3.0 ADDITIONAL INFORMATION TO NON MATERIAL AMMENDMENT

4.0 PROPOSED CHANGES TO CONDITION 4

CHANGES TO APPROVED CONSENTED DRAWINGS INCLUDED IN THIS NMA APPLICATION

173_PL1_GE_02_P3
PROPOSED SIDE ELEVATION

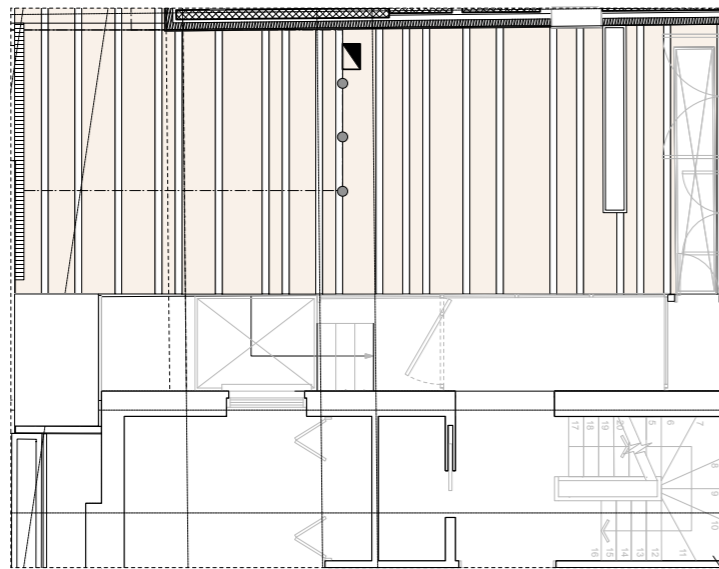
- AREA UNDER FULL PLANNING APPLICATION
PLANT REF NUMBER PP-08264900
- CHANGES TO APPROVED CONSENTED
DRAWINGS INCLUDED IN THIS NMA
APPLICATION

3.1 ADDITIONAL INFORMATION NEW ELEMENTS TO REAR COURTYARD

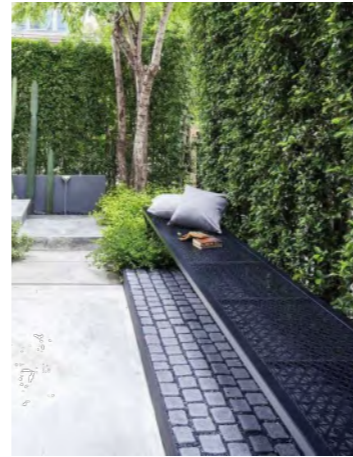
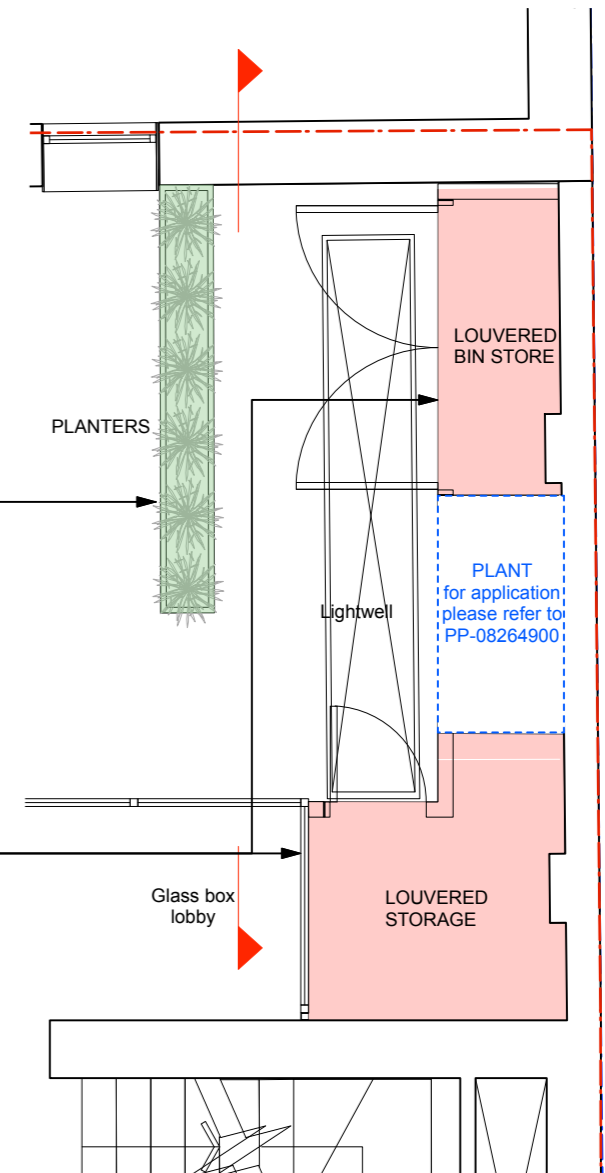
Planters

Aluminium Power Coated Louvers
RAL colour 7043
For Acoustic Spec refer to Full
Planning Application PP-08264900

3.2 ADDITIONAL INFORMATION- NEW MATERIALS

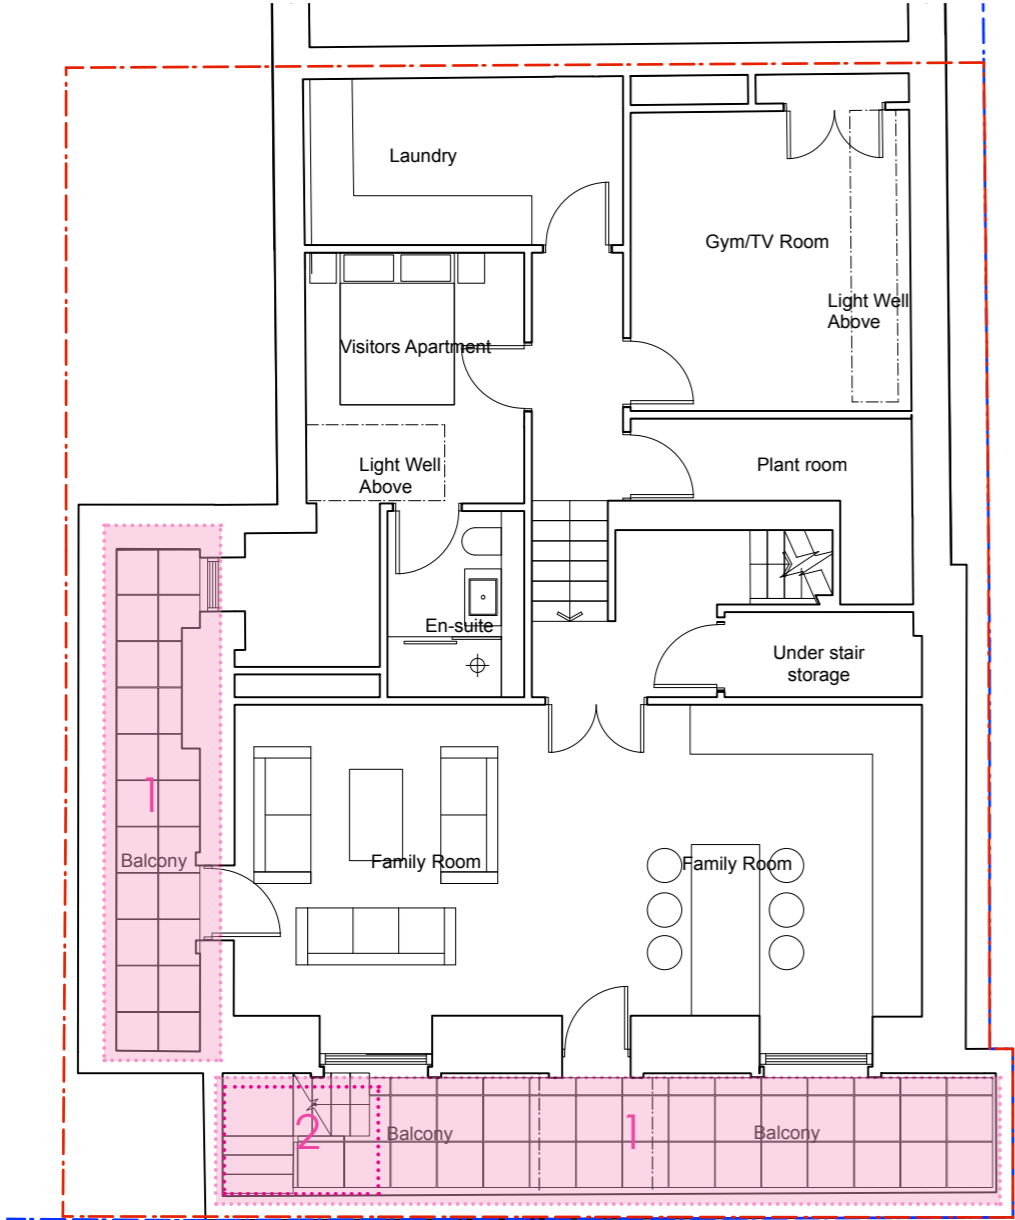
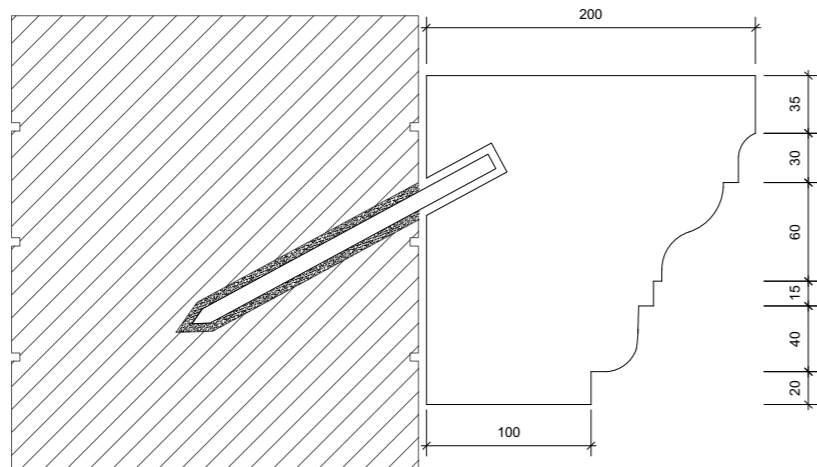
1. Balconies (lightwells) to the side and front elevation of the house have paving which is deteriorating and in poor state. Proposal includes those pavers to be Yorkstone to match the original intended design,

2. Existing external staircase is in poor condition and we are proposing complete replacement of the existing staircase. Proposal would include staircase to have matching metal handrail and Yorkstone threads as per intended original design.

173_PL-COND_04D_01_P3
PROPOSED FRONT ELEVATION

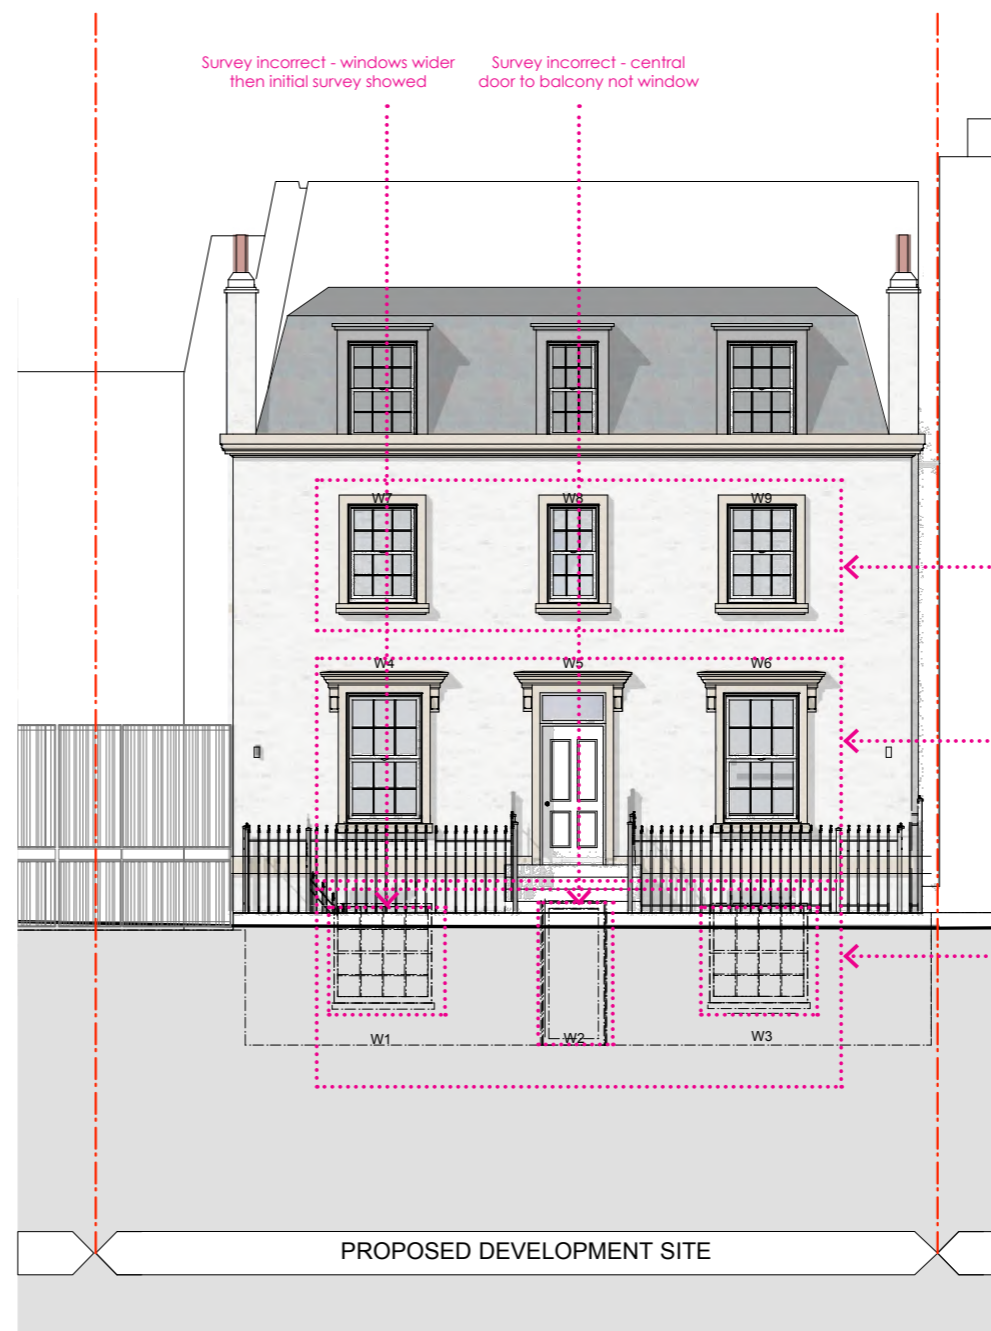
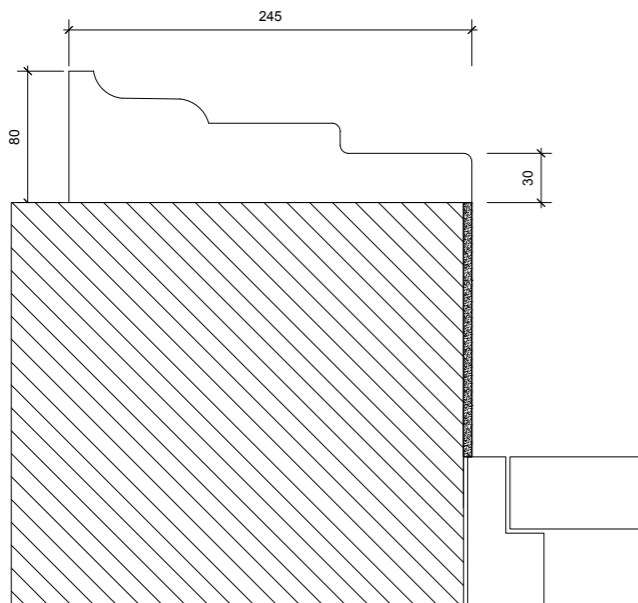
BASEMENT WINDOWS (W1 and W3)
Existing Cill to be removed, as they have significant cracks, with a new stone cill formed with upstand to receive window.
Profile to be added to the frame on three sides oversailing the existing base to the reveal.

BASEMENT DOOR (W2)
Existing concrete plinth to be clad over with a new stone cill.
Profile to be added to the frame on three sides oversailing the existing base to the reveal.

GROUND FLOOR WINDOWS (W4 and W6)
Existing cill to be removed, as they have significant cracks, with a new stone cill formed with upstand to receive window.
Profile to be added to the frame on three sides oversailing the existing base to the reveal.
The rolls and entablatures to be fixed through the wall beyond the frame.

ENTRANCE DOOR (W5)
Existing concrete plinth to be clad over with a new stone cill.
Profile to be added to the frame on three sides oversailing the existing base to the reveal.
The rolls and entablatures to be fixed through the wall beyond the frame.

FIRST FLOOR WINDOWS (W7 - W9)
Existing Cill to be removed, as they have significant cracks, with a new stone cill formed with upstand to receive window.
Profile to be added to the frame on three sides oversailing the existing base to the reveal.

Consented documents discharging condition 4 have been approved considering window cills and the surrounds for the windows to be Yorkstone. New proposal includes stone to be **Portland stone** to match the original design

173_PL-COND_04D_02_P2
CONSENTED SIDE ELEVATION

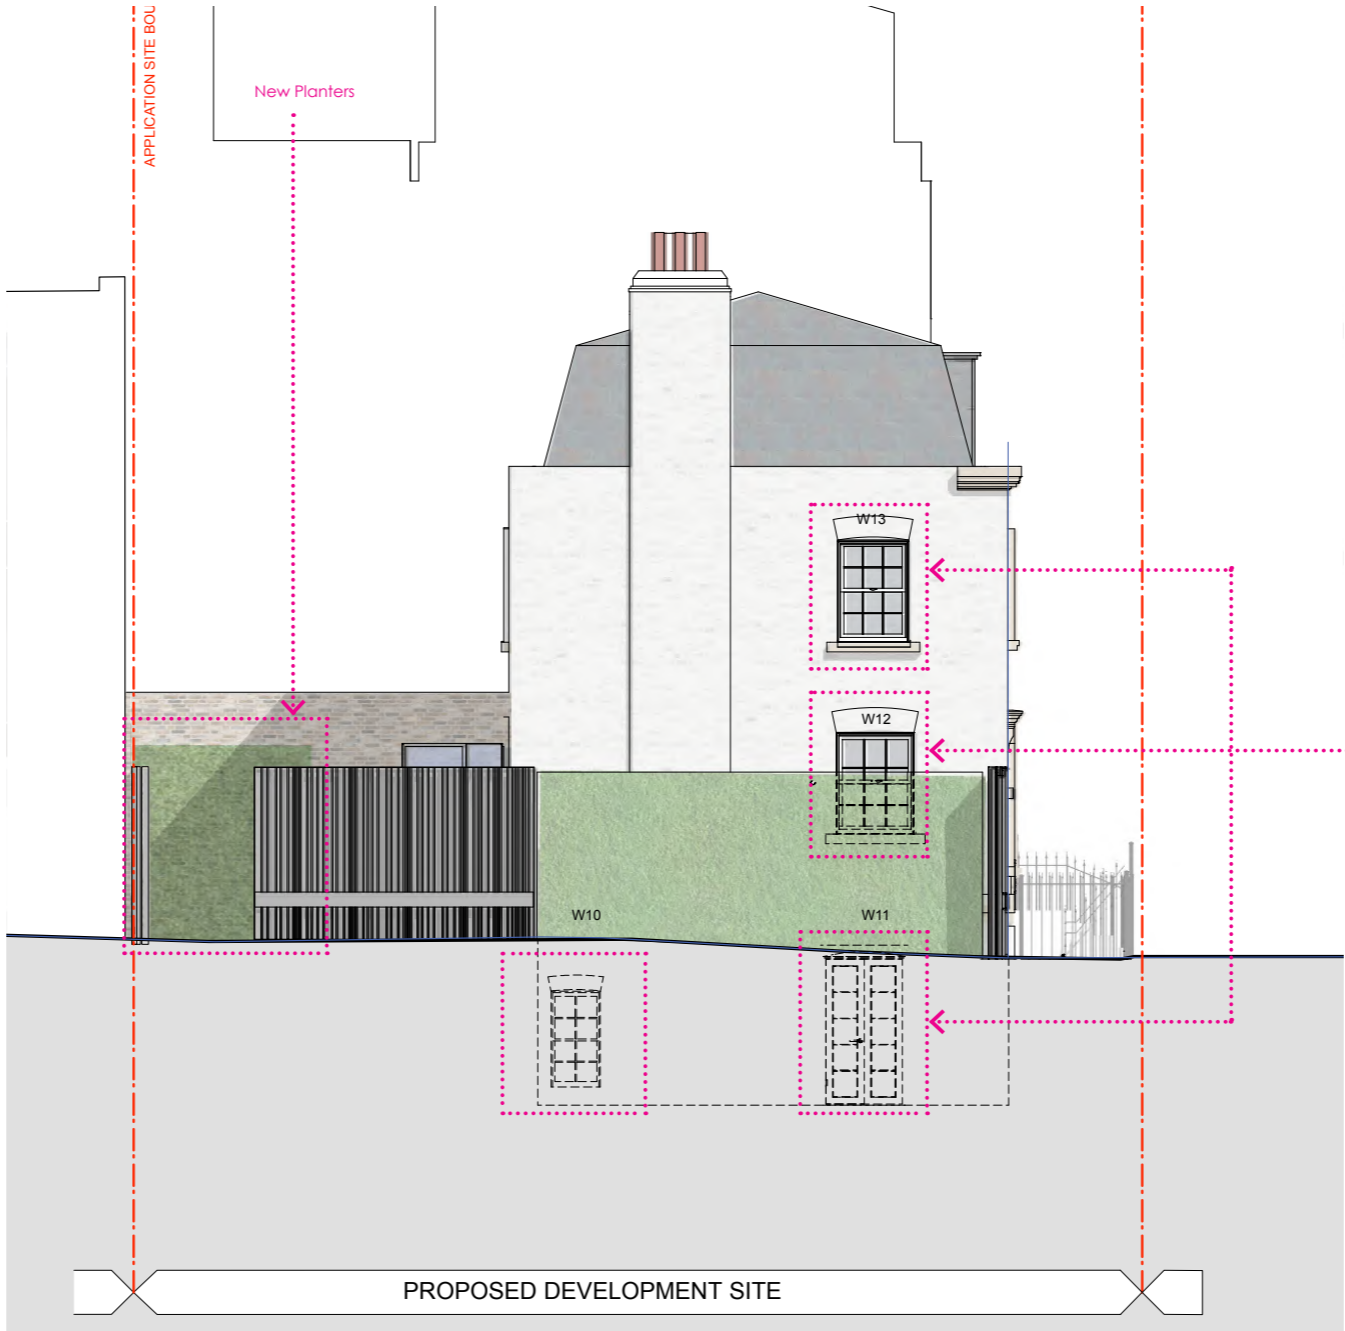
GABLE ELEVATION WINDOWS and Door (W10 - W13)
 New cills to be provided as there are not enough existing cill which can be salvaged and re-used.

Consented documents discharging condition 4 have been approved considering window cills and the surrounds for the windows to be Yorkstone. New proposal includes stone to be **Portland stone** to match the original design

173_PL-COND_04D_04_REV P
PROPOSED LIGHTWELL STAIRCASE

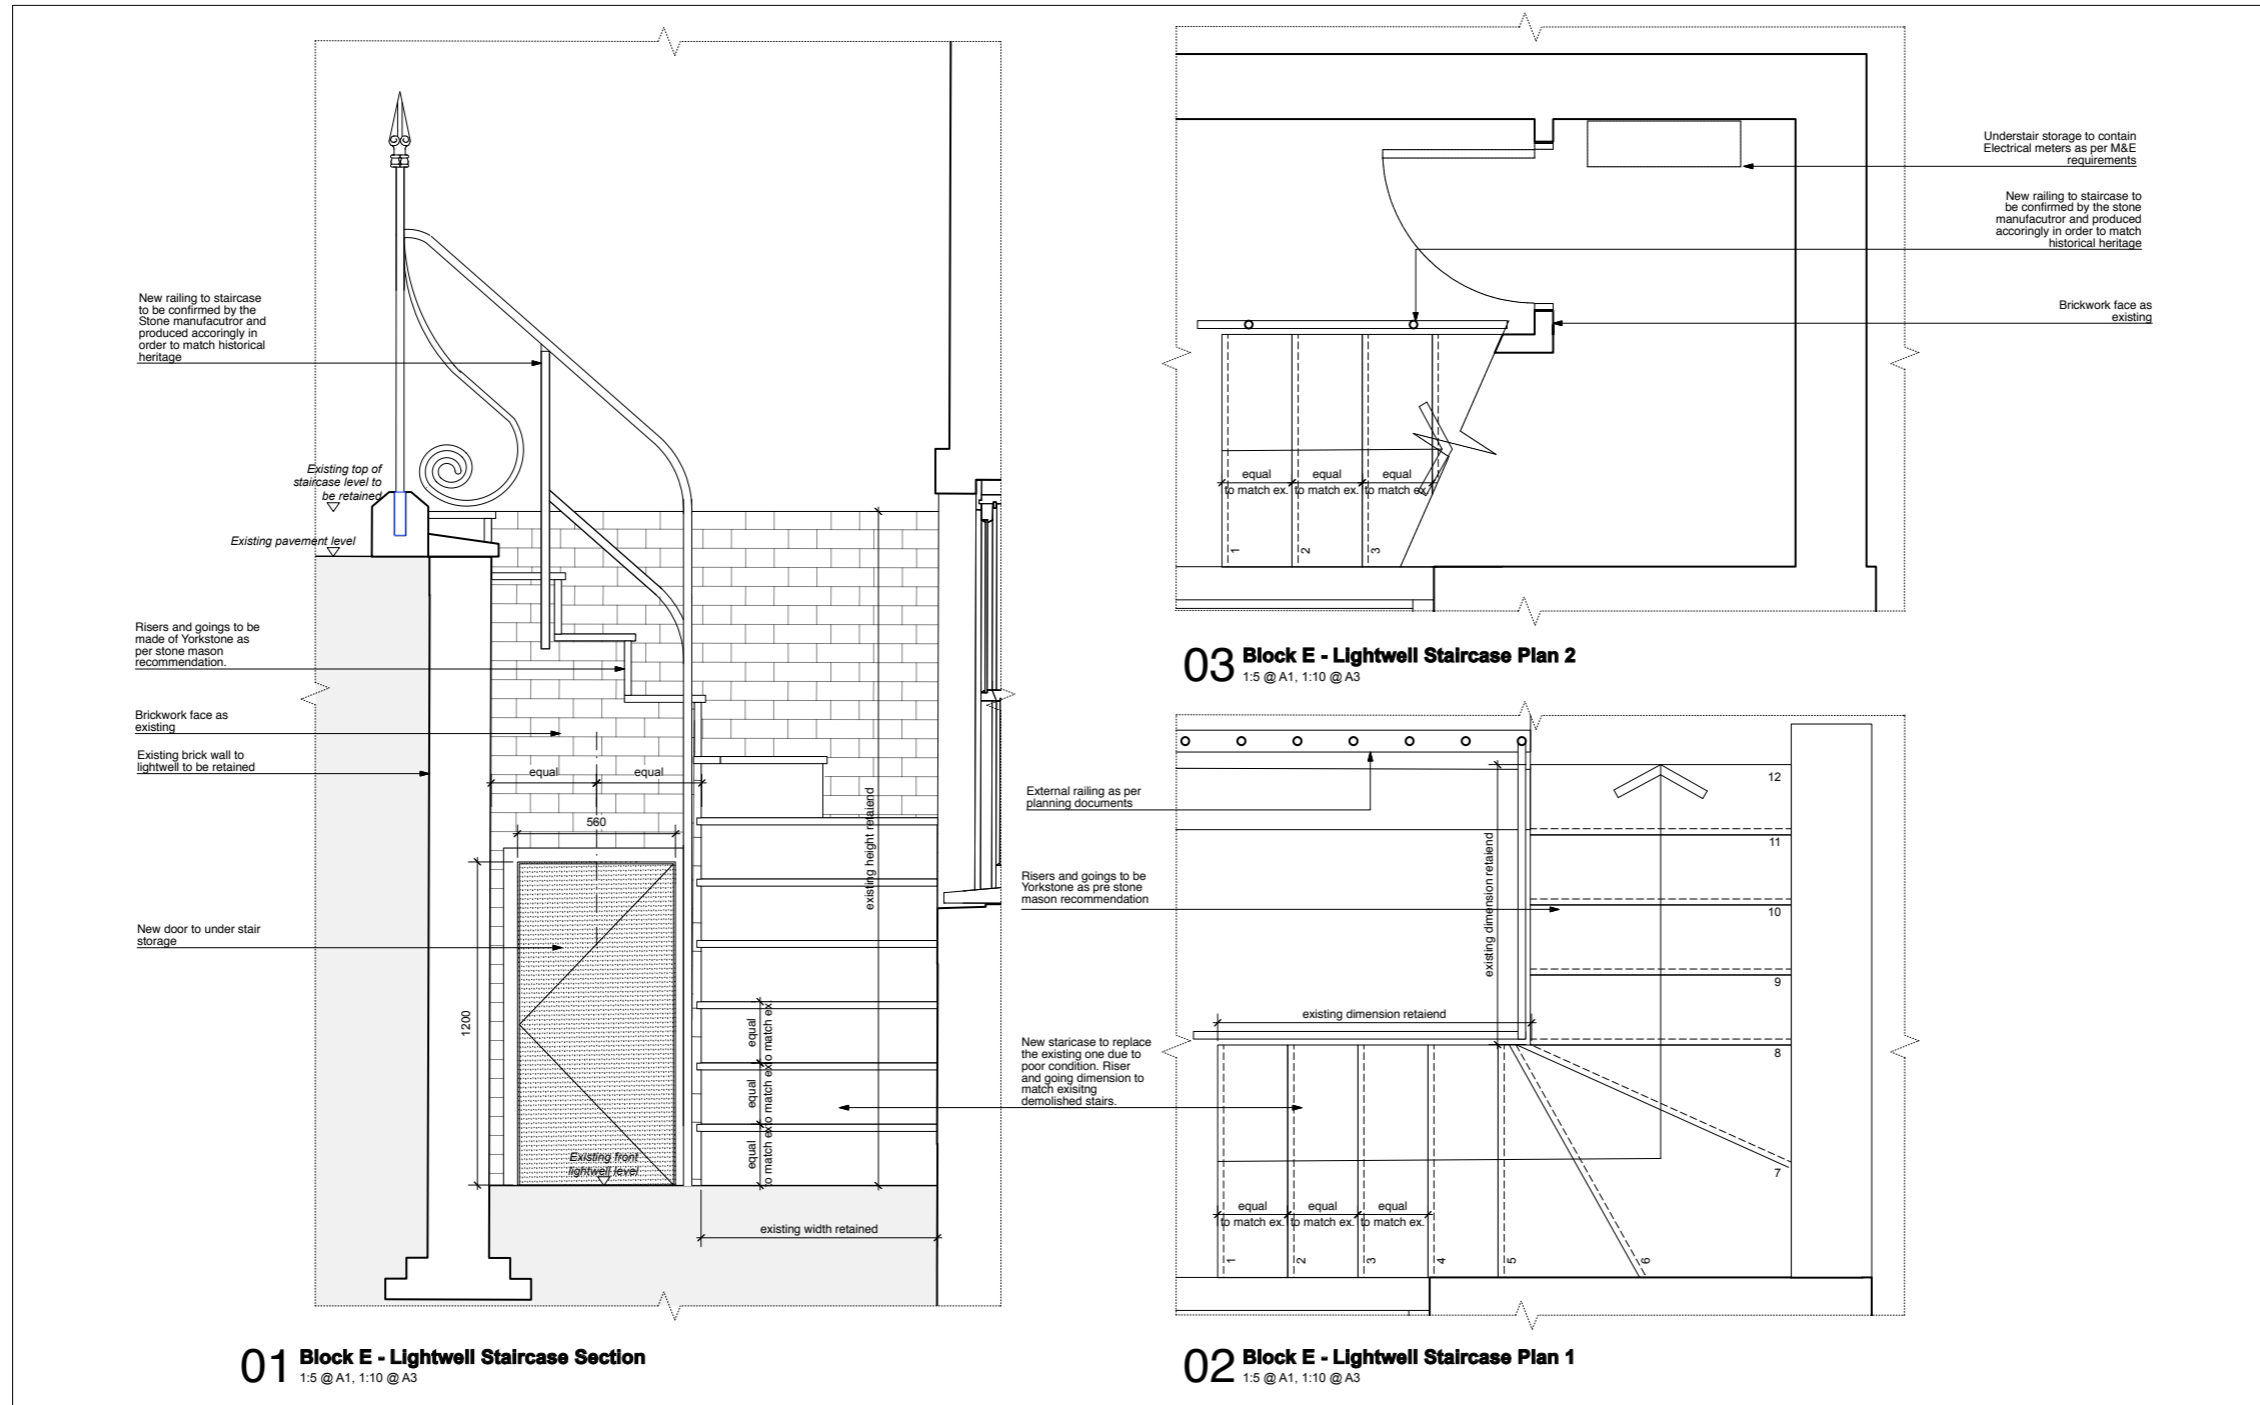
4.4 NEW CONDITION DRAWING - LIGHTWELL STAIRCASE
